FREEDOM OF INFORMATION COVERSHEET

FOI reference: TCCSFOI 21-006

From: [Redacted]
Sent: 13/05/2019 6:44:48 PM AEST (GMT +10:00)
To: [Redacted], [Redacted], [Redacted]
Cc: [Redacted], [Redacted], [Redacted], [Redacted], [Redacted], [Redacted]
Mail Number: CMC-RFI-004117
Subject: Antill/Mouat Red Light/Speed Camera - no signage detailed

FILE No. SHEET: 52 OF 75 A1
STATUS: IFC
DRG No. 02-ACM-DRW-CIV-LI-4152 04 EDMS No.

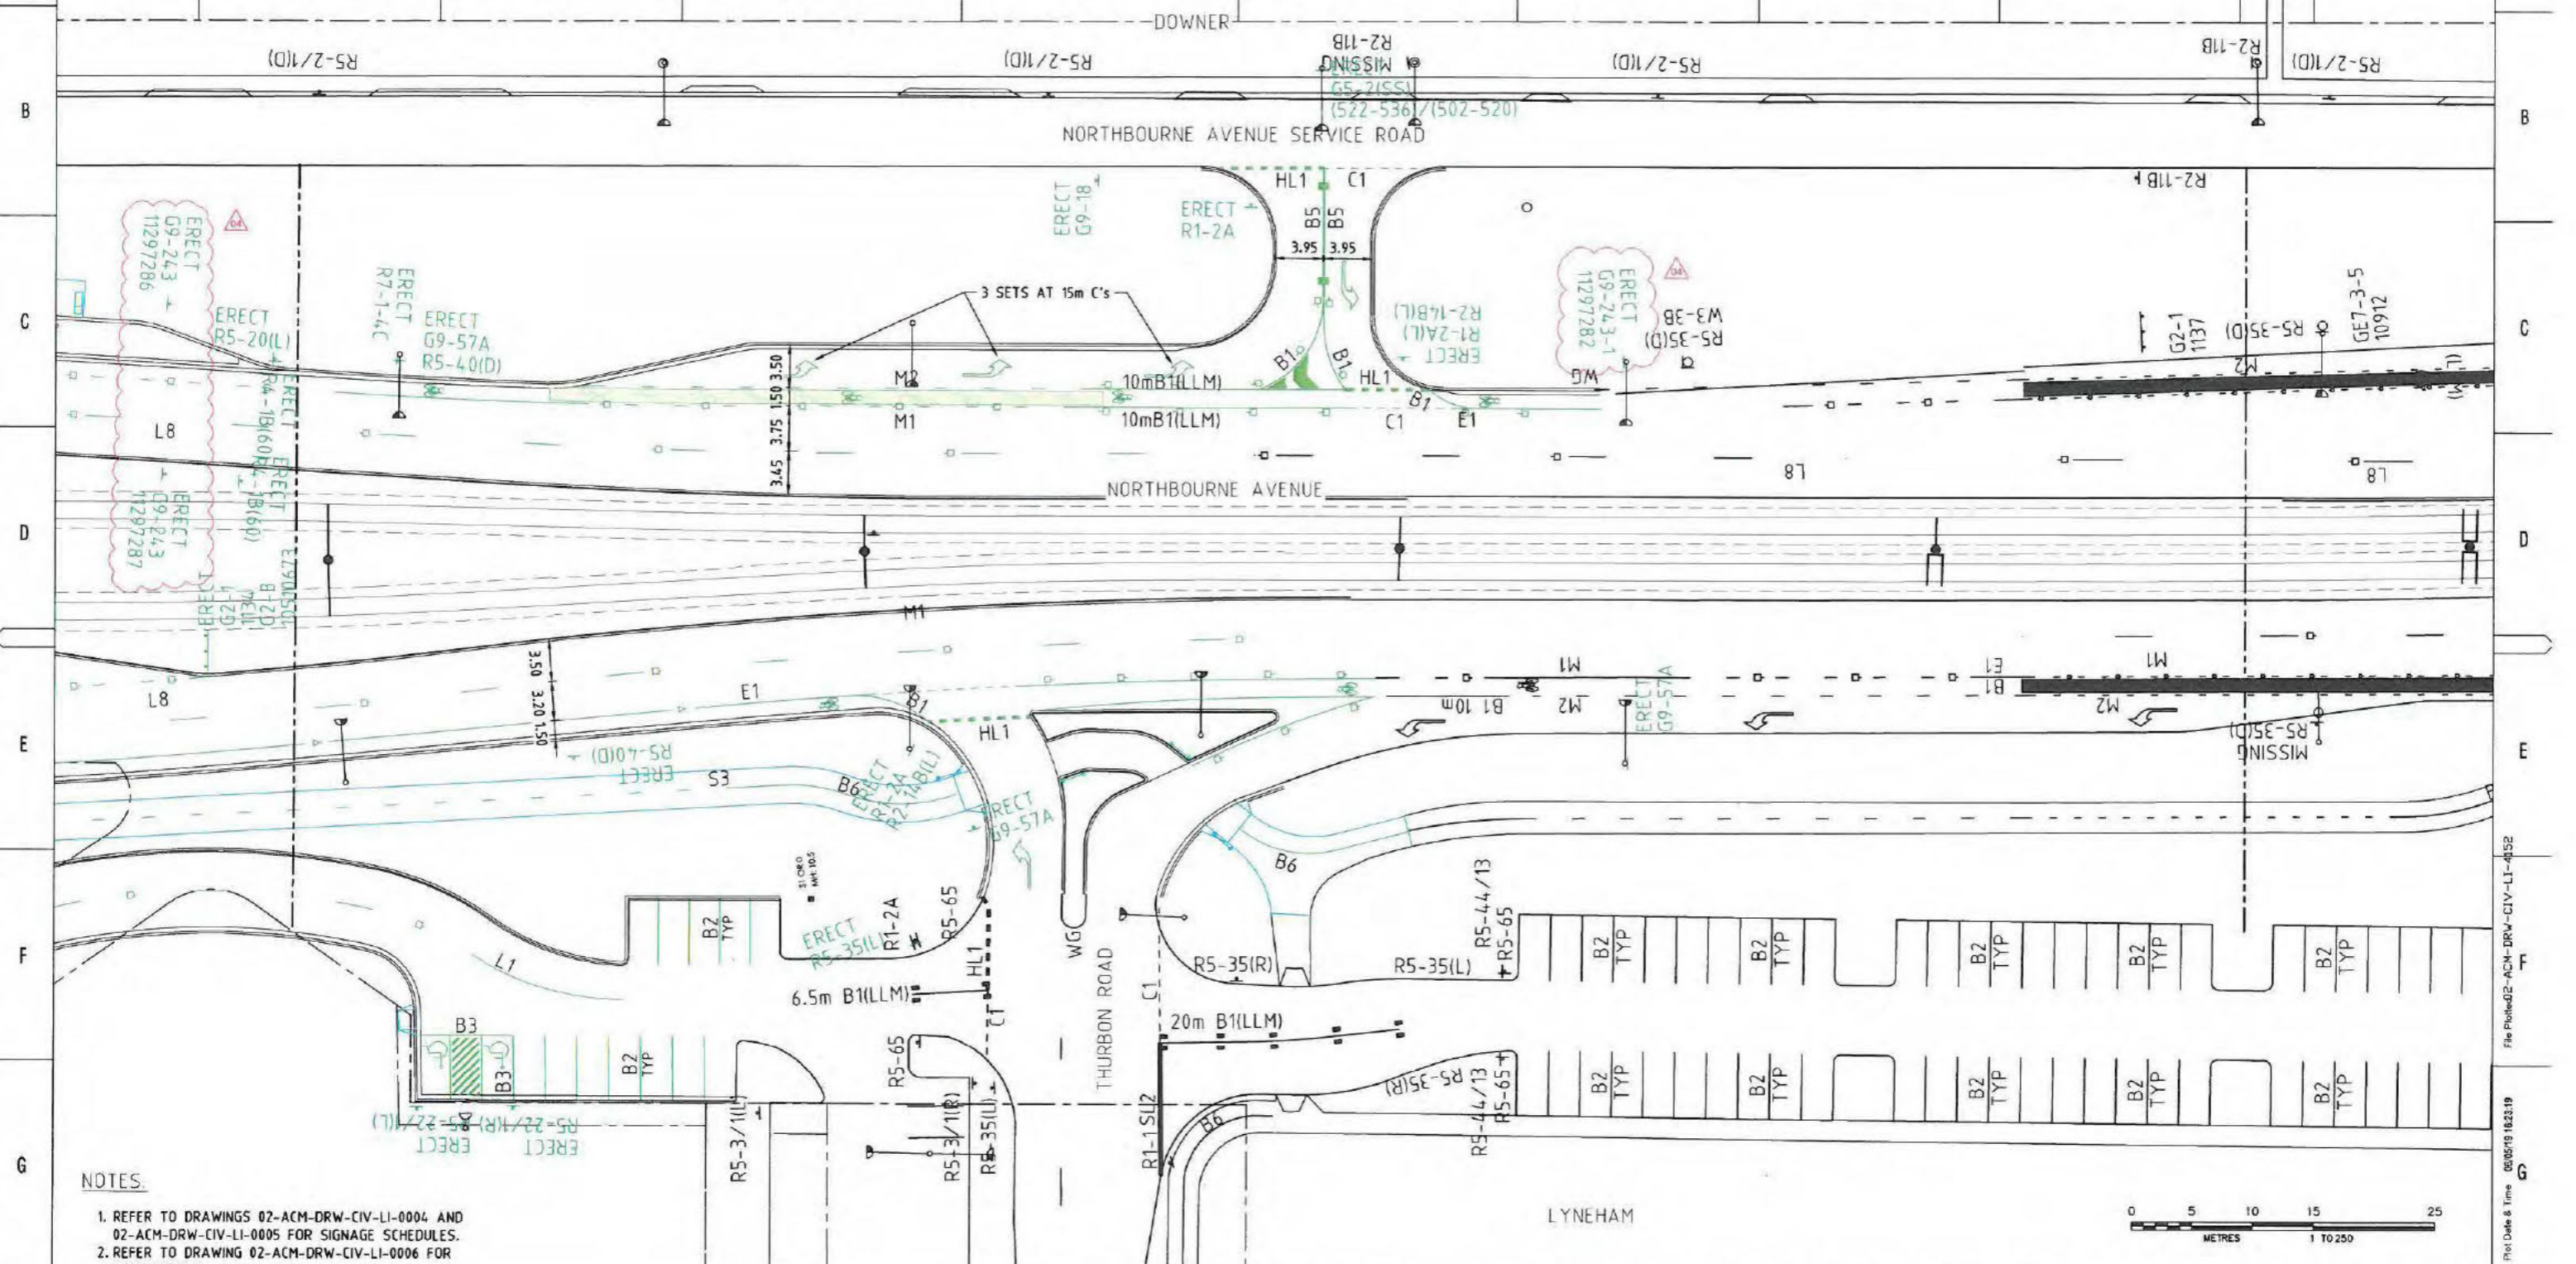
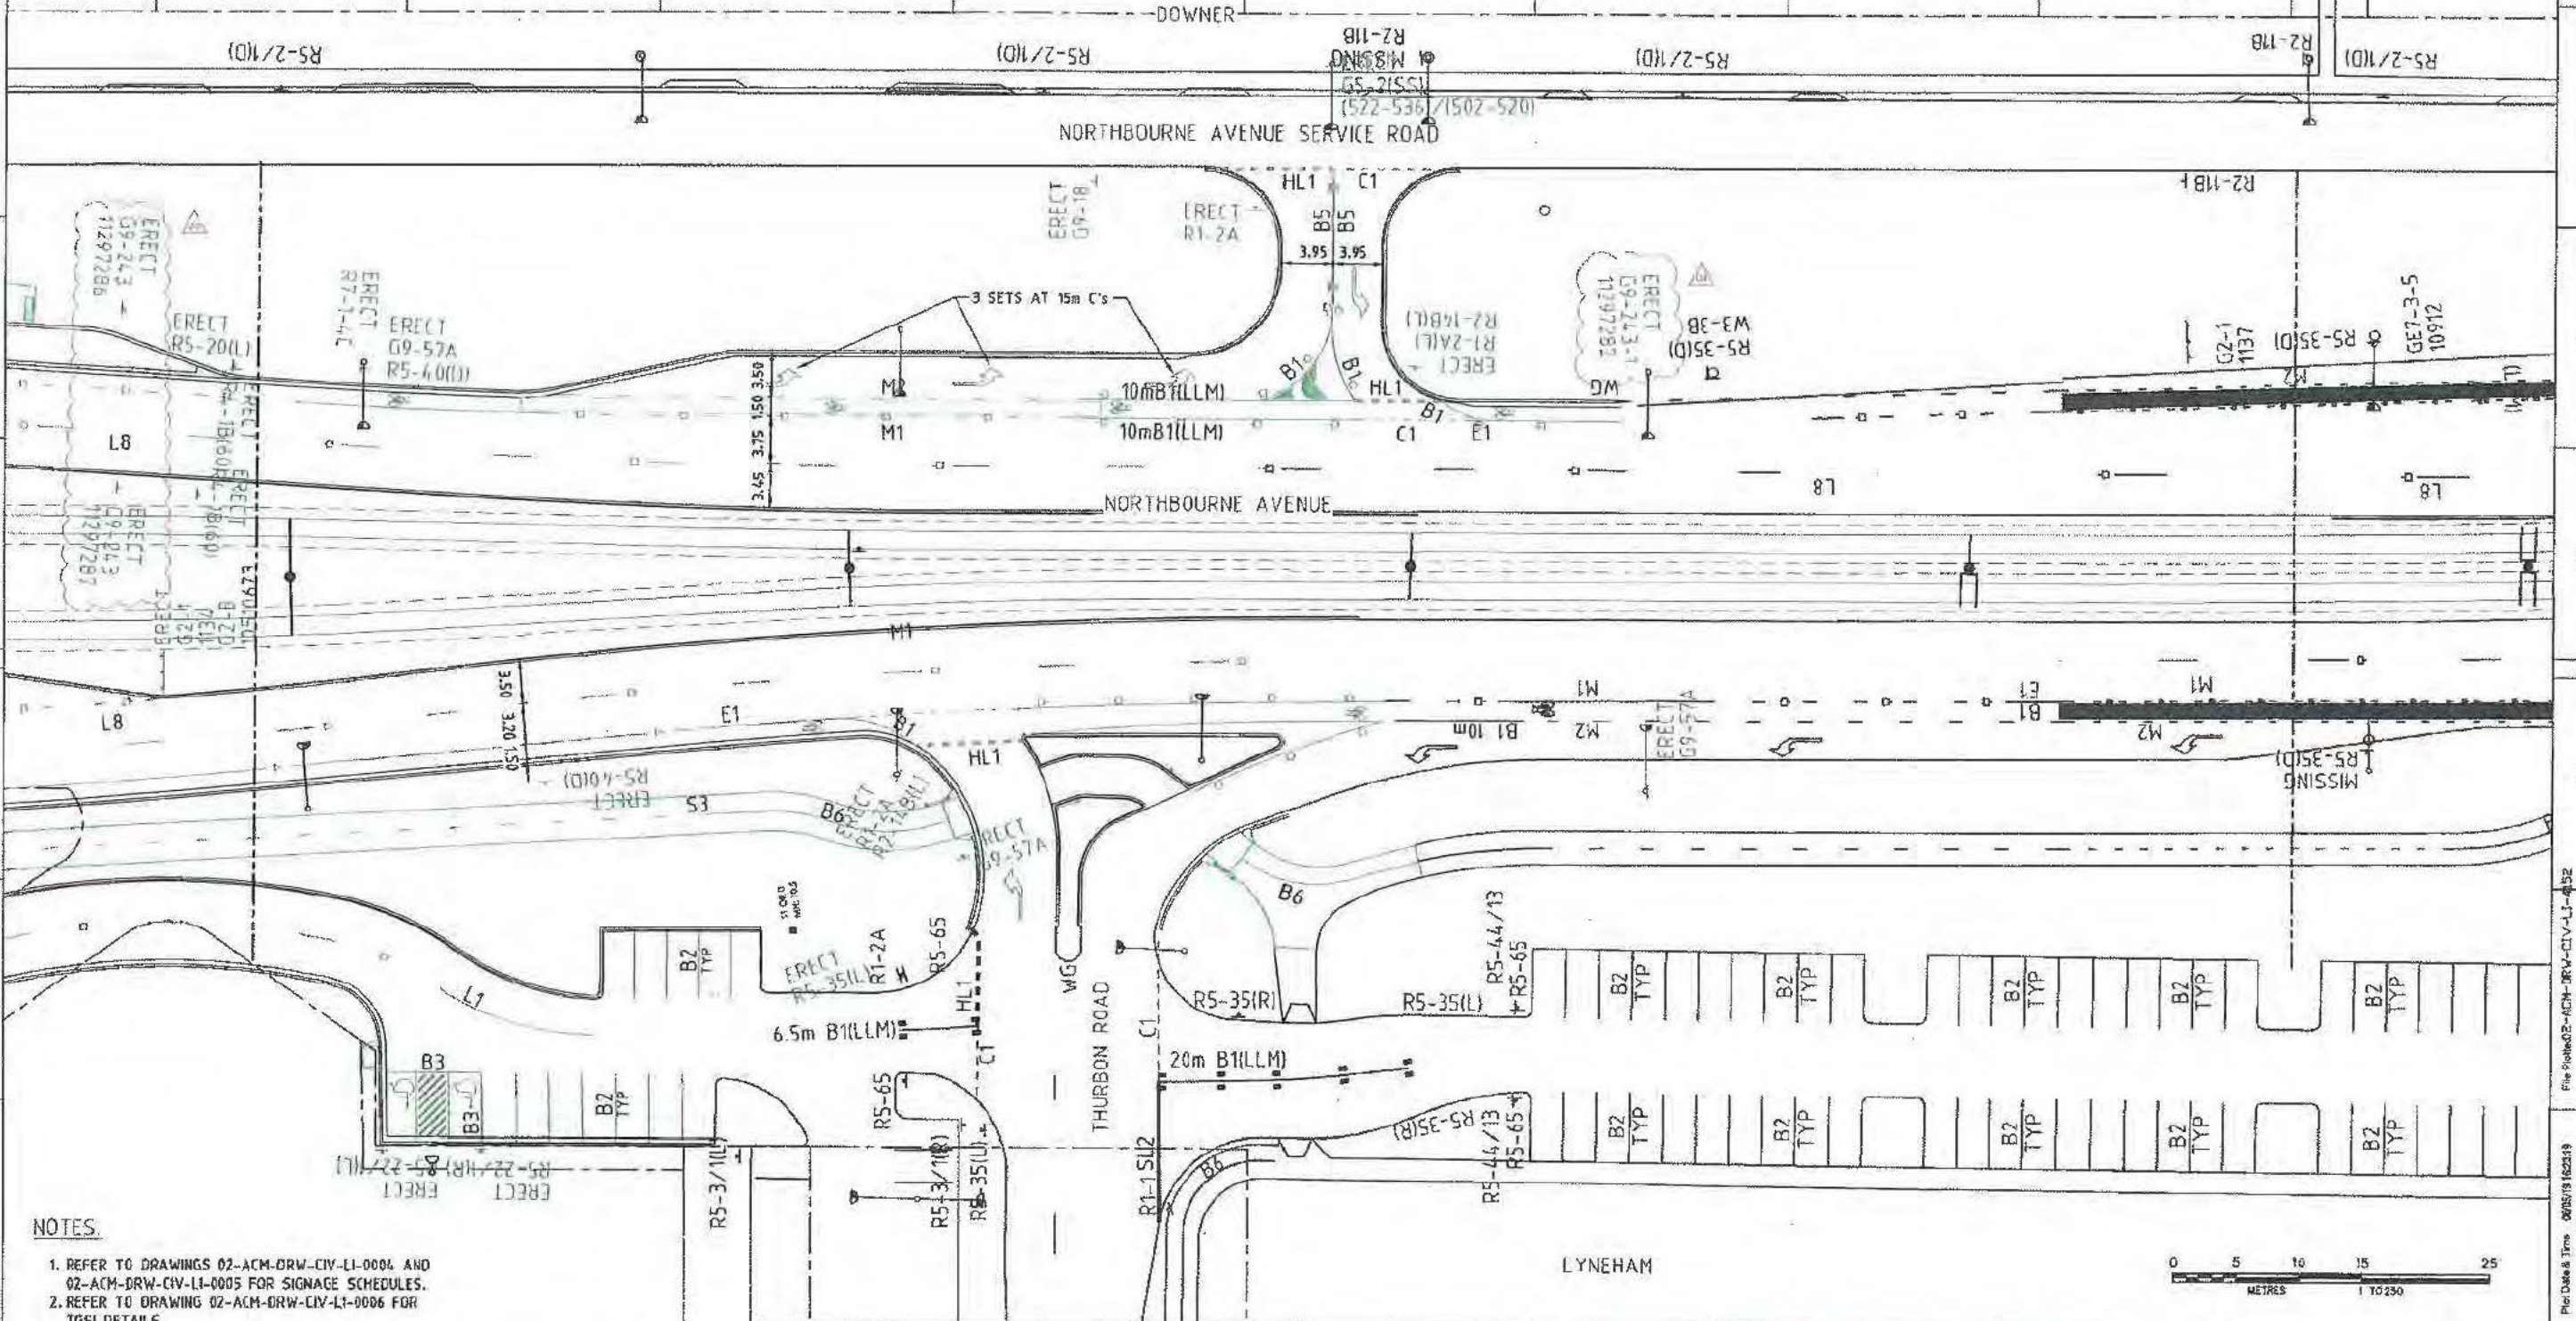
Thank you for your update on this via outlook (copy attached). When a decision is made for the signs at Antill, can you please advise the original sign numbers and also provide the inventory form for the signs as the signs will need to be re-manufactured.

For the median sign, there is a sign G6-243-1 which is shown in the general vicinity. Is this the correct sign number? If not, can you please also advise the correct number for this sign.

part of our scope near the Antill/Mouat Intersection was to remove the existing Red Light/Speed camera in the centre median and relocate it to the SB verge. The camera has been moved and will be operational again soon but TCCS are querying the advanced warning signage for this. They have indicated that these cameras normally have gated signage (e.g. one on either side of the road or in this case, one on the verge and one in the centre median.

Can you please review and provide clarification of what is required here and provide the required red line mark ups. I have attached a picture of the signs that TCCS require.

Thanks for the response. We note that your sketch contains a combination of both Option 1 and Option 2. Can you please confirm we are to proceed as per your sketch (ie total of 3 signs - 2 gated at the bus stop and one extra on the streetlight pole).

FILE No.	SHEET: 51 OF 75	A1
STATUS: AS-BUILT		
DRG No.	02-ACM-DRW-CIV-LI-4151	06
EDMS No.

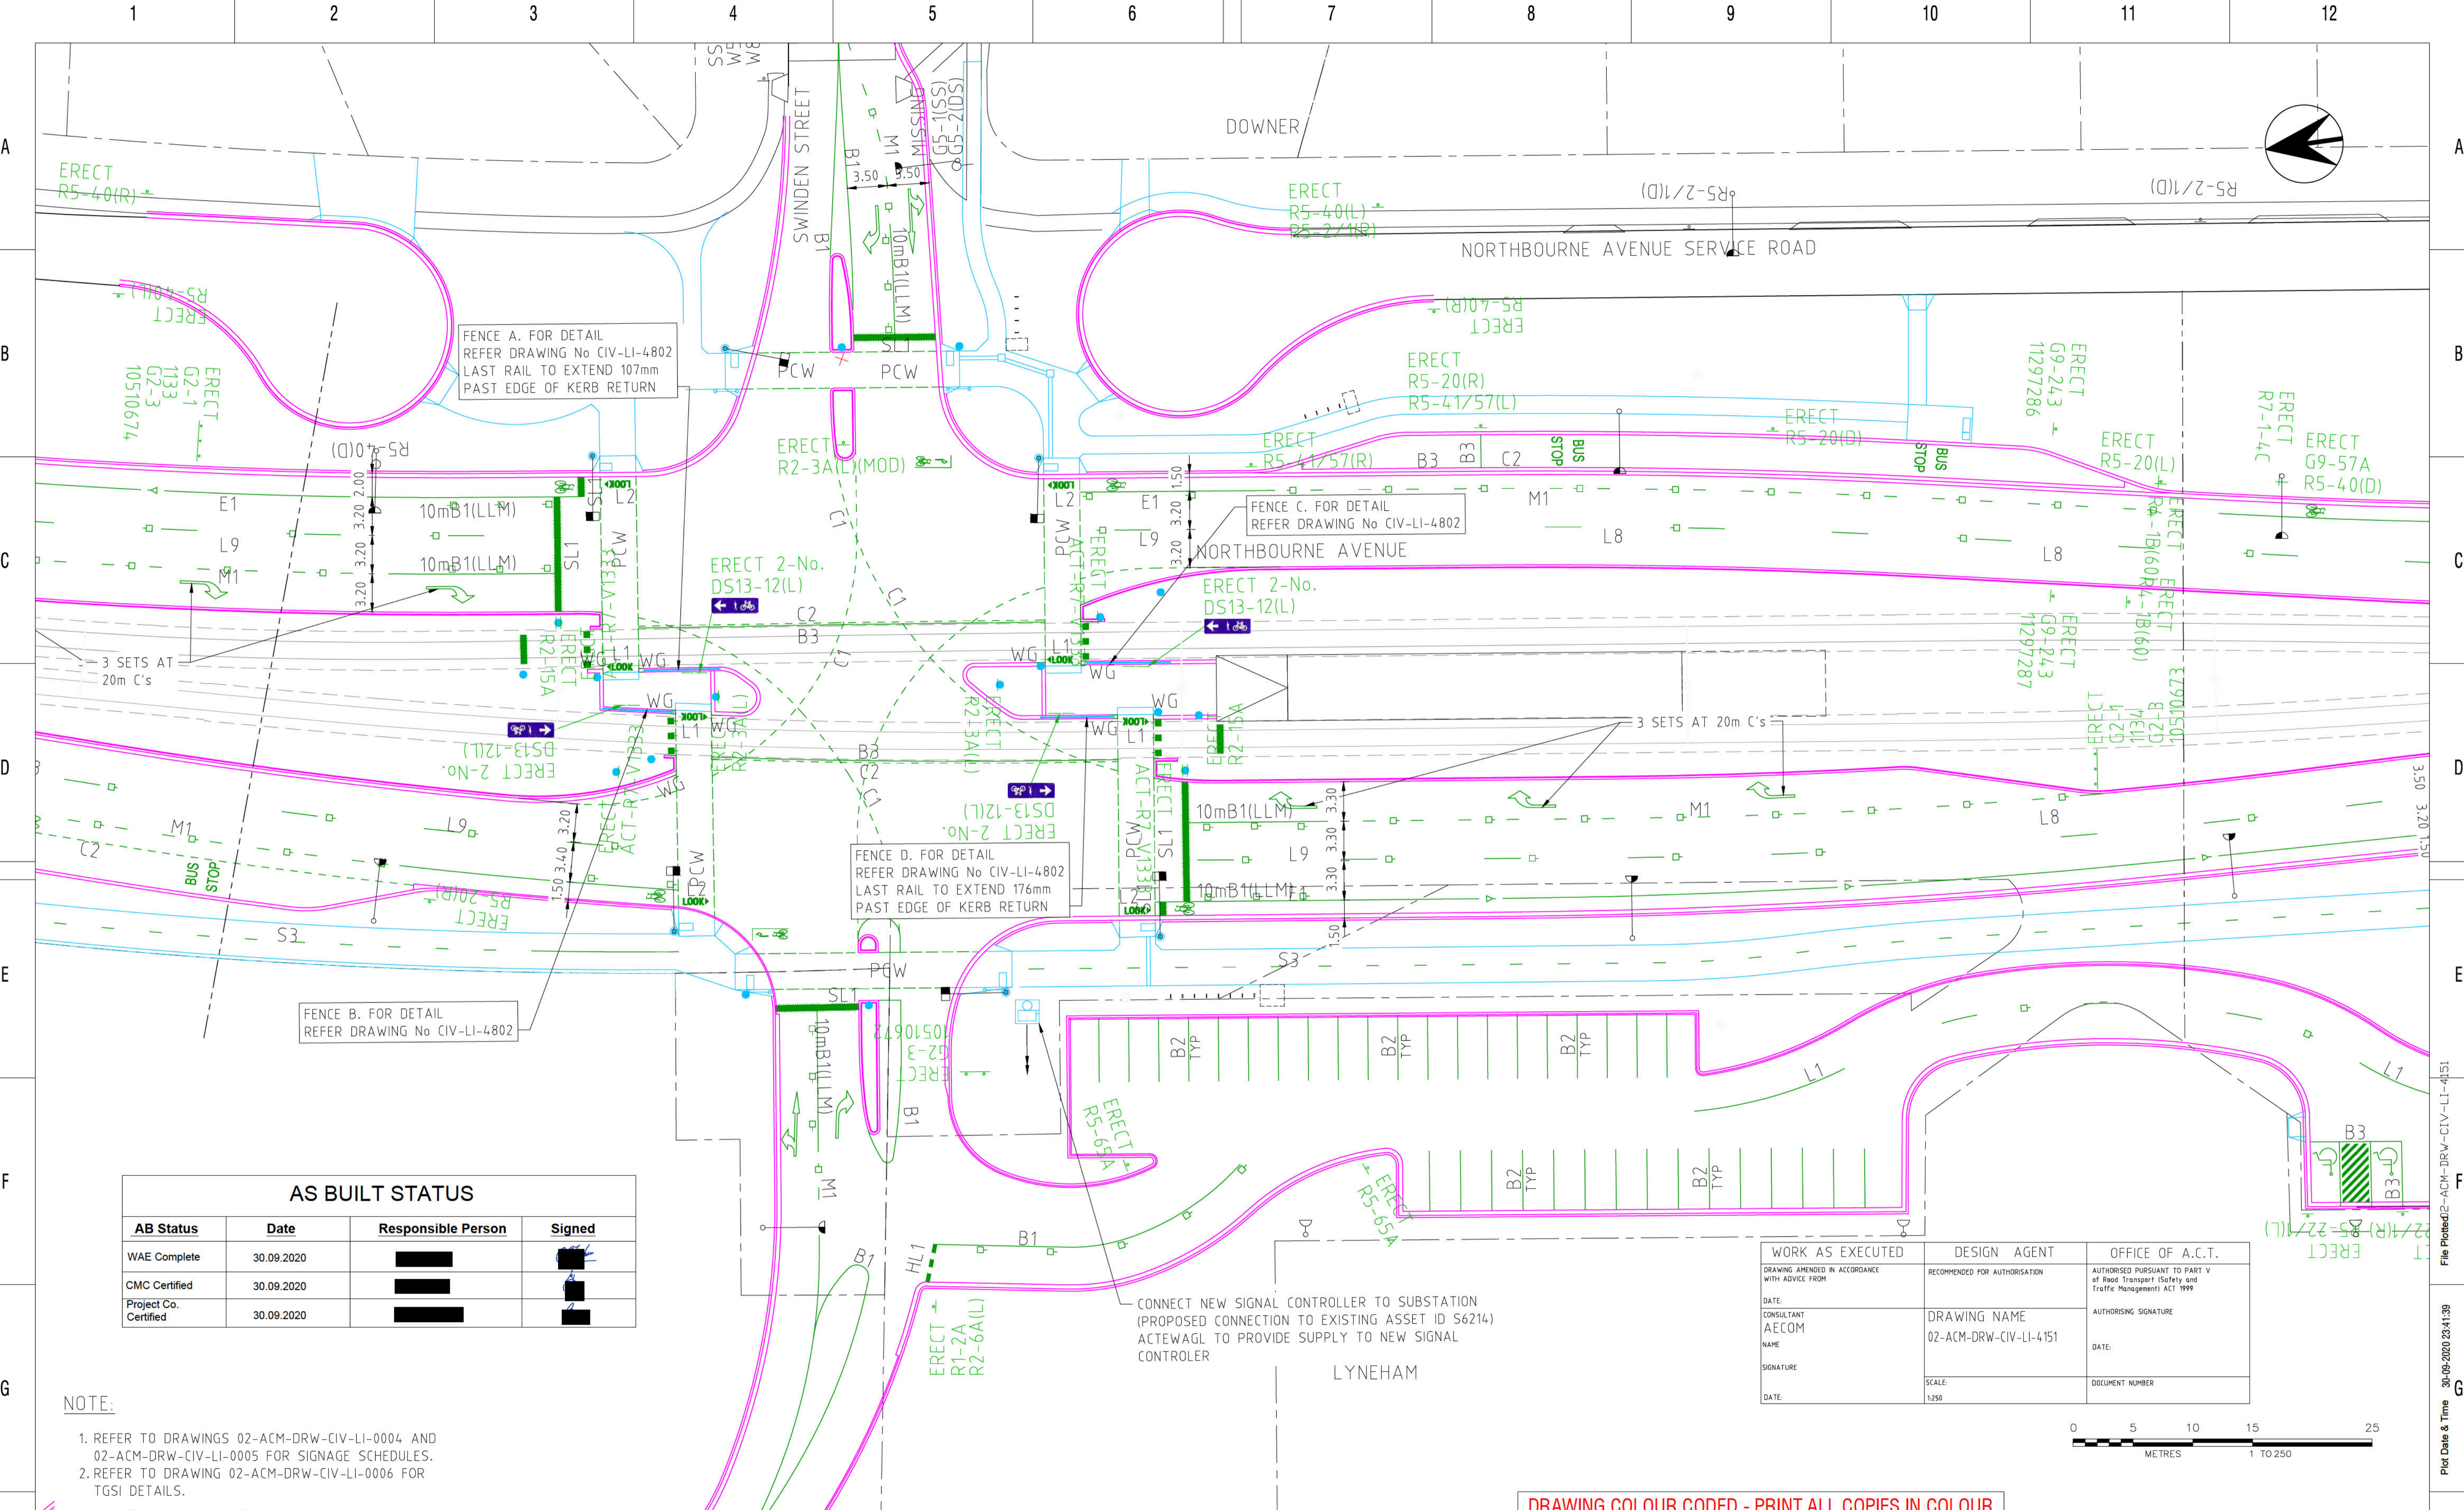
Hi Shelly
Attached is the final locations for the speed camera signs which AECOM have approved, and are issued for Territory acceptance / comment. TCCS early response to this request is greatly appreciated.
Regards
[REDACTED]
Design Manager

The drainage drawing doesn't show any utilities or pits in this location, however inspect on site to make sure the sign location does not clash with any rail infrastructure.
